**HALL-MILLER MUNICIPAL AIRPORT (ATA)
ATLANTA, TEXAS**

TxDOT CSJ No.: 2419ALNTA

ADDENDUM NO. 2

February 19, 2025

FENCE CORNER DETAILS

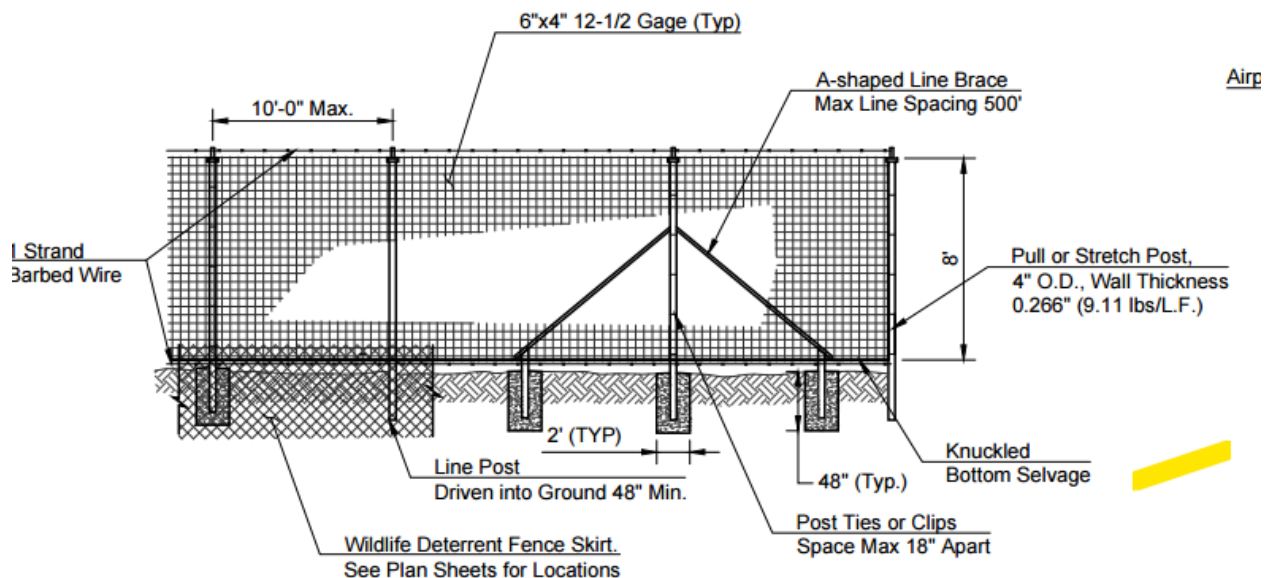
14. The corner detail indicates a fence with Barb arms, 1-5/8 top rail, and 7 gauge tension wire. While Game Fence detail does not have any barb arms, 1-5/8 top rail, or 7 gauge tension wire. Please clarify the Game Fence Layout.

18. Spec book Item F164 2.0 C - Chain link skirt fabric - Has height requirement of 5' wide. The bid proposal form indicates a 3' skirt. Please clarify width requirement, over lap requirement, and depth Required. 164-3.7 Installing chain-link skirt fabric. Excavate trench to the depth required for proper installation of the chain-link fabric. Obtain RPR's approval of depth of excavation before placing the wire fabric. Place the fabric and lap splice it to existing fence fabric and tie with wire ties at 2-foot (0.6-m) spacing. Cut wire fabric around fence post footing to allow proper placement. Backfill with native soil to original grade. Please clarify.

- a. Please see revised detail. The game fence shall have a single strand of barb wire at the top.
15. The note on DWG C3.0 #1. Line post every 100'. Is the intent to clarify that every 100' a line post must be set in concrete.

- a. The requirement is 5'. Please see revised detail and bid form.

SUMMARY OF QUANTITIES

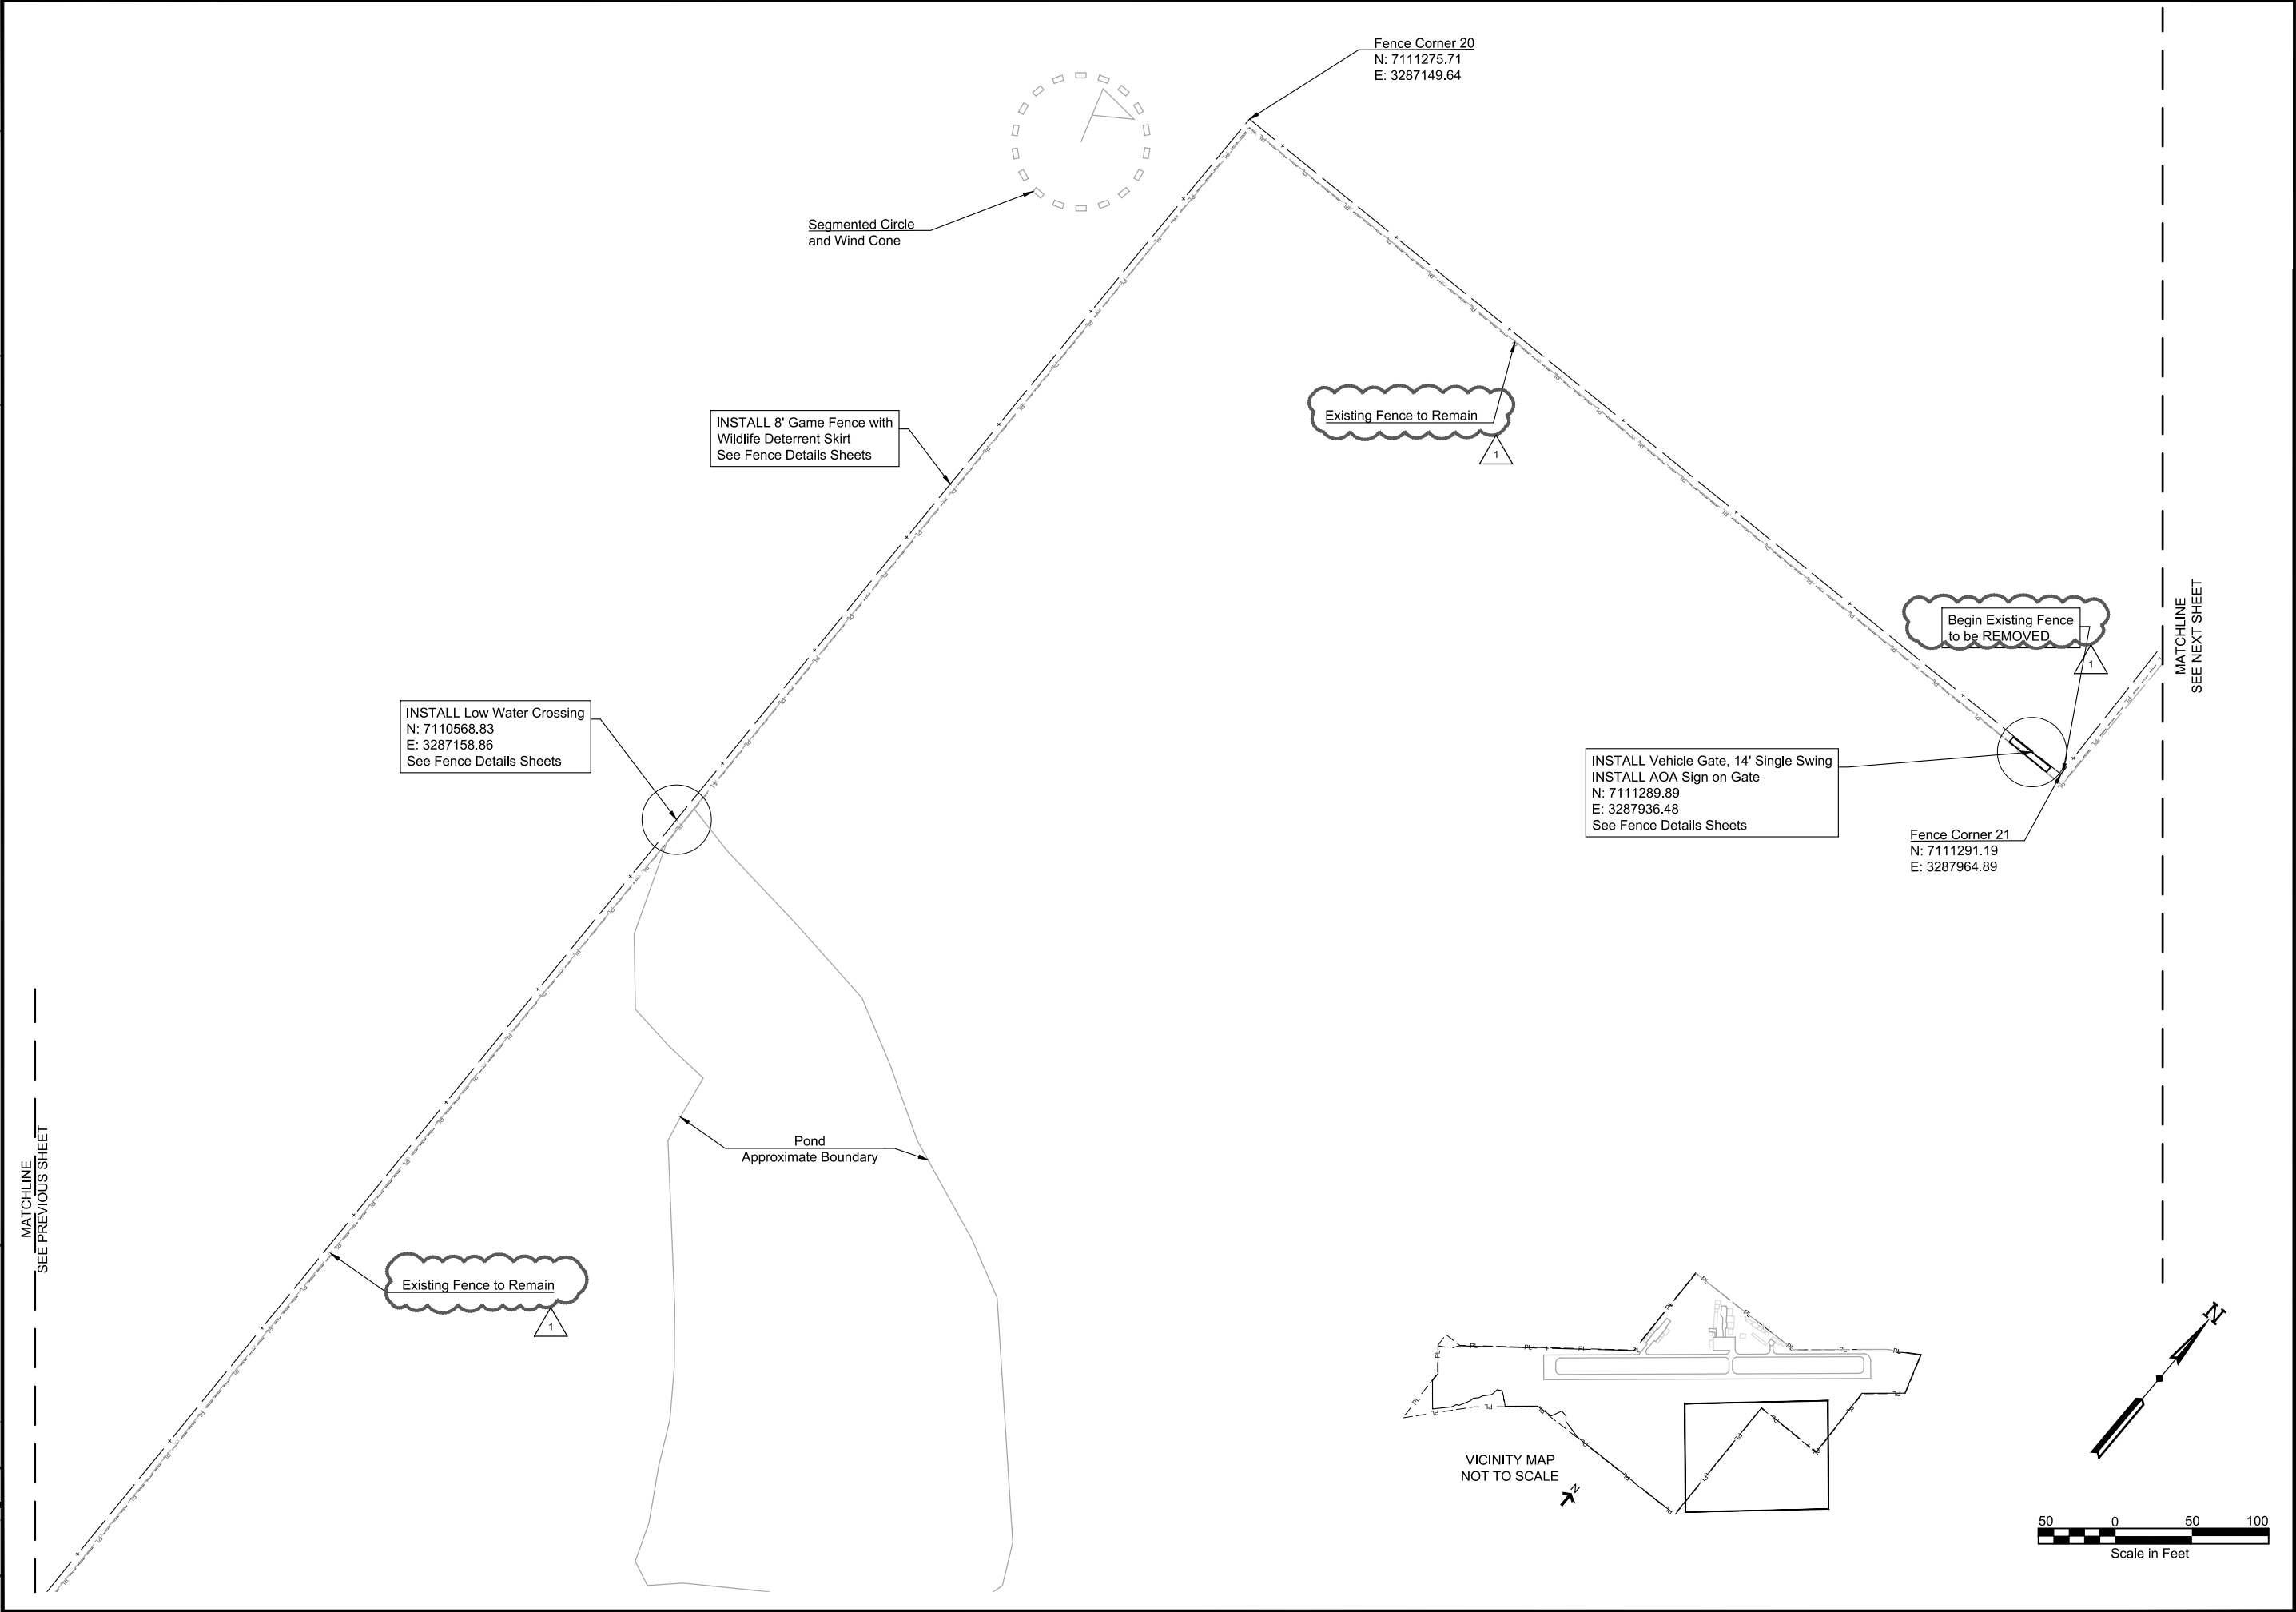
5. How many calendar days for this project?
 - a. The entire project will be 140 calendar days.
6. The plans call for 1 Acre of clearing & grubbing but clarifies to have a cleared 10' path for the proposed fence.

- i. This number has been revised to be 2.5 AC to reflect additional clearing around the fence alignment. No additional increase to seeding or bonded fiber matrix mesh shall be made.

FENCE PLAN

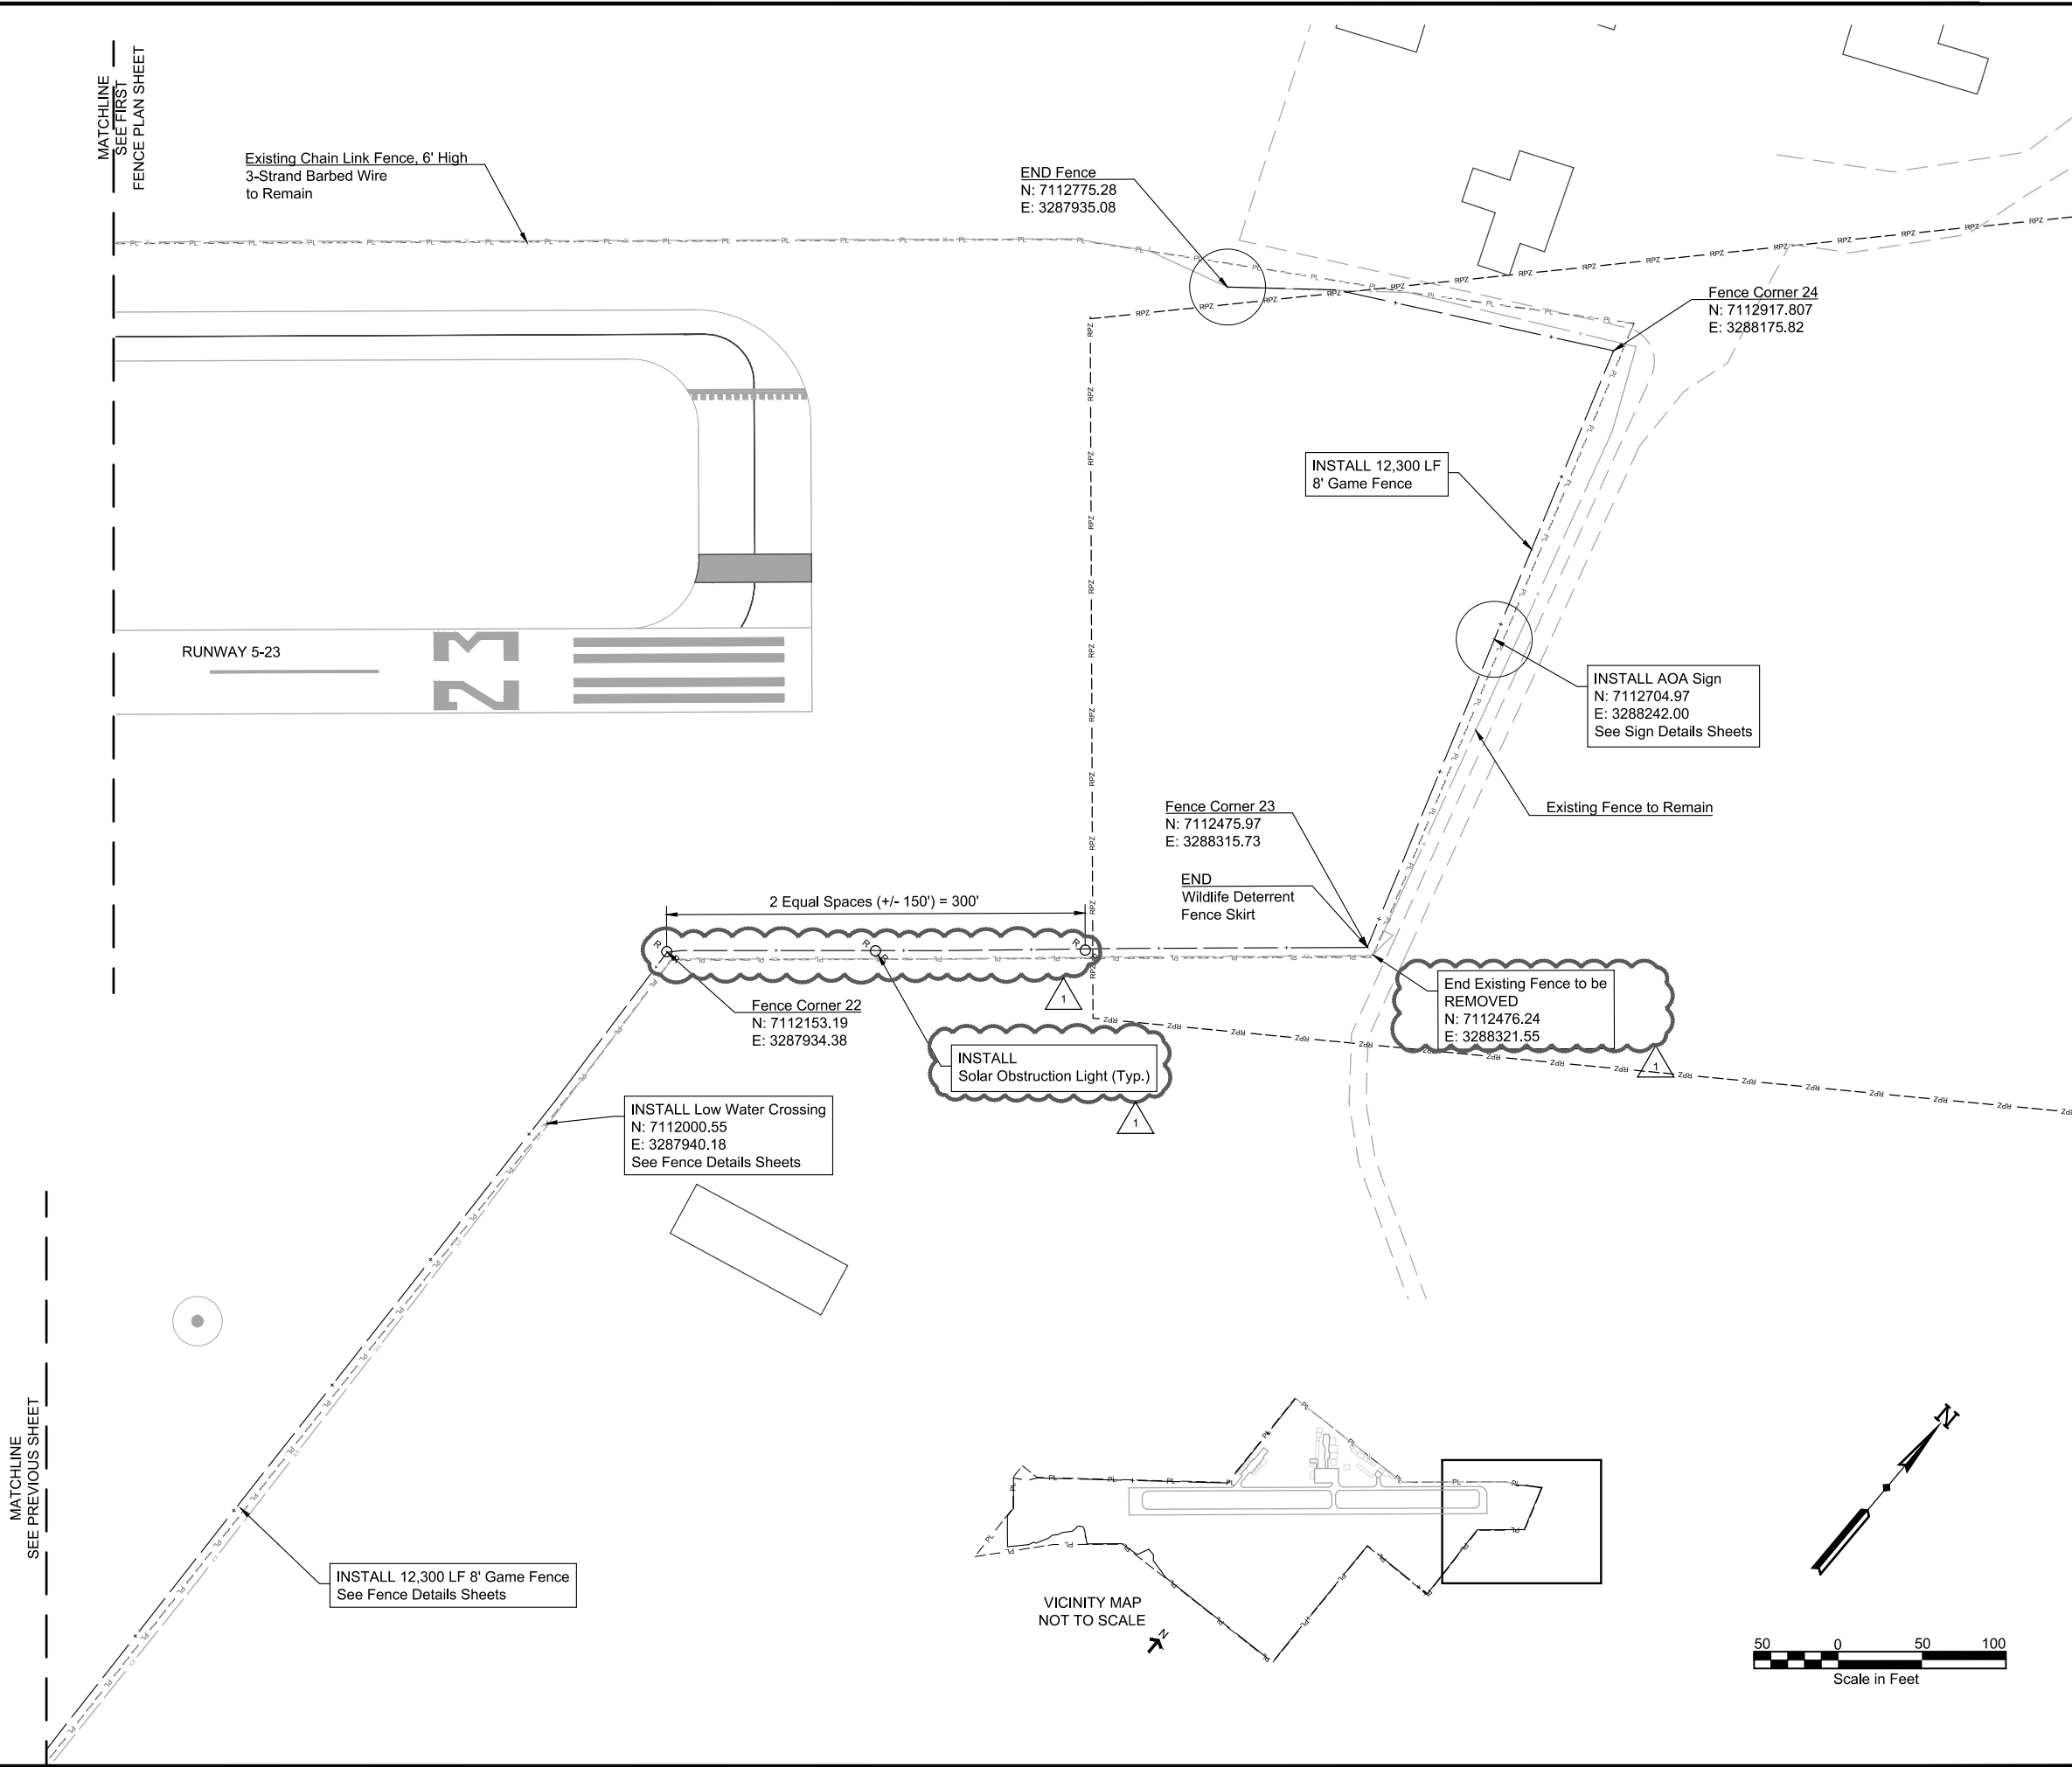
- 10. From fence corner 19 to fence corner 21, the neighboring property owner has recently installed a new barbed wire fence.
 - a. Plans call for removal of existing, but the property owner stopped us on-site and demanded that his new fence not to be removed.

11. Between fence corners 22 & 23, there are numerous materials stored on the neighbor's property against the existing fence to be removed.
 - a. Will this section of fence be removed as it isn't clear on the plans.

12. Between fence corner 23 & end of proposed fence, it calls for the removal of existing fence.
 - a. The existing fence is welded pipe fence, are we to remove this as called?

- a. In an instance between fence corners 2 & 3 there are several spots where the brush would be 20-40' off the fence. Should we leave the trees/brush standing between the proposed fence and airfield? (Some cases 10-30' widths).

- i. This property owners' fence will not be removed. The proposed airport game fence will offset the existing fence.
 - b. He also requested for there to be enough space between the proposed fence and his existing fence to be able to mow and kept clean.

- ii. Correct, please see detail.
 - c. Please advise on whether we are to remove the new fence or install the new per neighbor's request.
 - i. Answers have been provided above in regards to this segment from 19 to 21 and this property owner. This project will require coordination between the landowners, stakeholders, RPR, and engineer, which will be ongoing from the pre-construction meeting and throughout construction.

- i. This existing fence section will be removed between 22 and 23. Between points 23, 24 and 25 is an existing pipe fence, which will remain in place per the property owners request. The new proposed fence will offset the existing pipe fence in this location. Any existing three-strand barb wire in this area will be removed and replaced with the proposed game fence.

- i. This has been previously answered. This property owner requested this pipe fence be left alone. The new airport game fence shall be offset.
13. In areas where brush extends out past the 10' path for proposed fence inwards towards the airfield, would we need to expand the clearing?

- i. In this area between 2 and 3, the contractor shall remove all trees between the fence and the taxiway pavement. The contractor shall also remove trees on the inboard side of the fence towards the runway between points 6, 7, 8, and 9.

FENCE CORNER DETAILS
No Scale

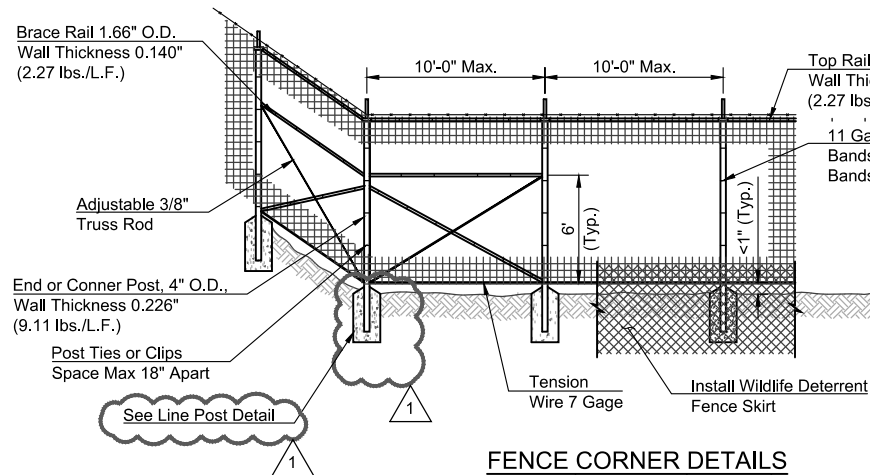
- 31. Can you provide a deer hearing gate detail?
 - a. See the revised detail sheet.
- 32. Single barb wire on top of the fence, and another detail states the arm. Can you clarify?

- a. See revised detail. Single barb wire on top.
- 33. Controller for the gate arm, can it be equal to?
 - a. Yes. However, the intention is the controller can be easily replaced or parts sourced regionally.

AUTOMATIC CHAIN-LINK SLIDING GATE

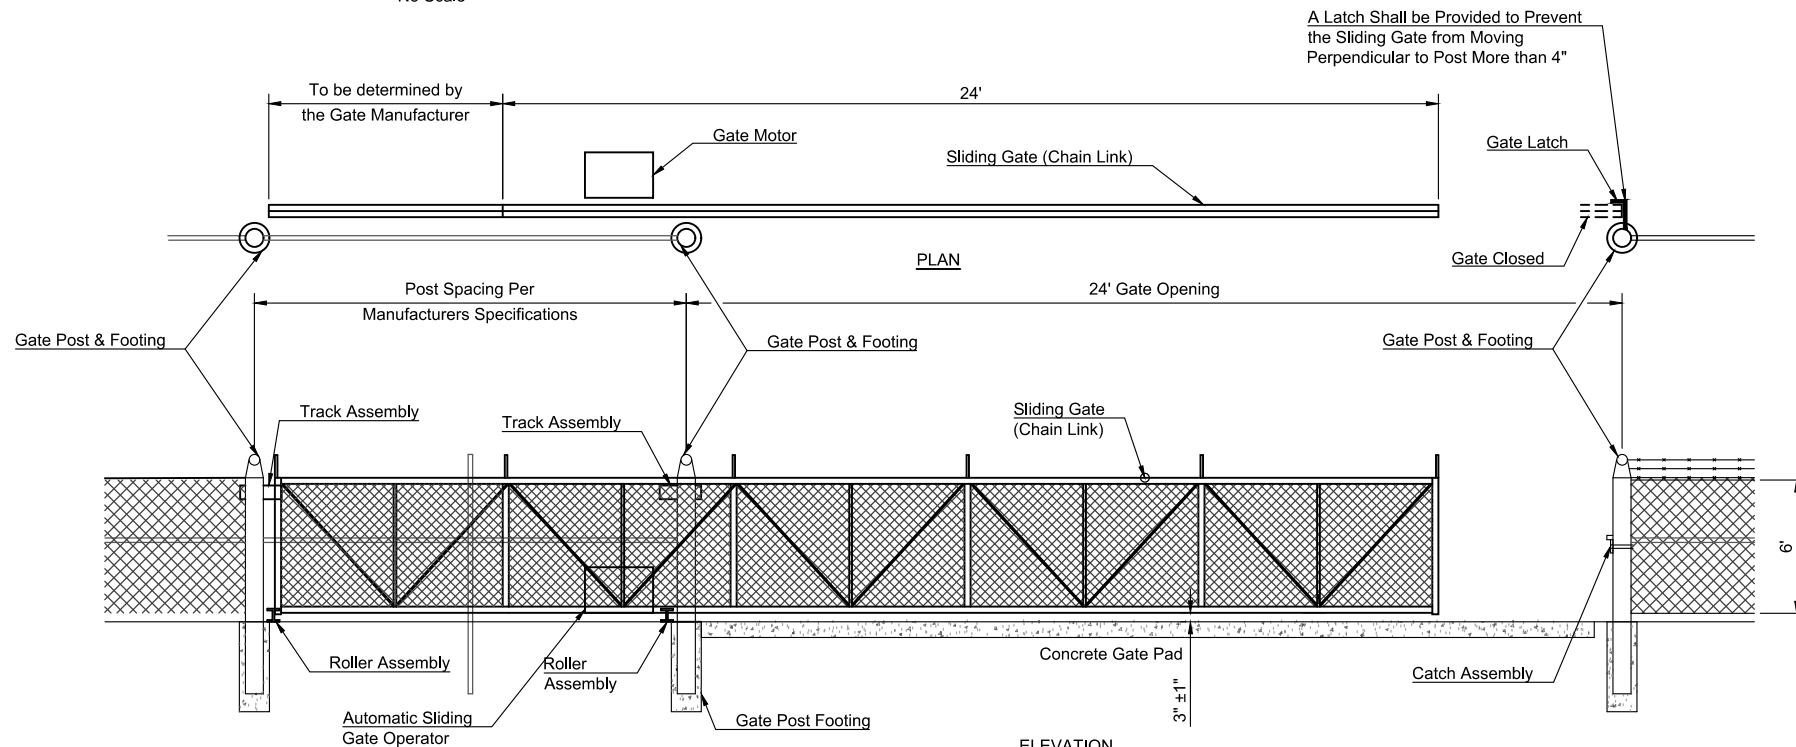
- 35. Will the gate be V-Trak or Cantilever?

- a. Cantilever. See updated revised detail sheet.
- 36. If there are tree limbs that are just outside of the 10' width should the contractor go ahead and remove them?
 - a. The contractor shall work with the RPR to identify these areas in the field for additional removal limits.
- 37. Is the intent to skirt around the Pond?
 - a. Yes.
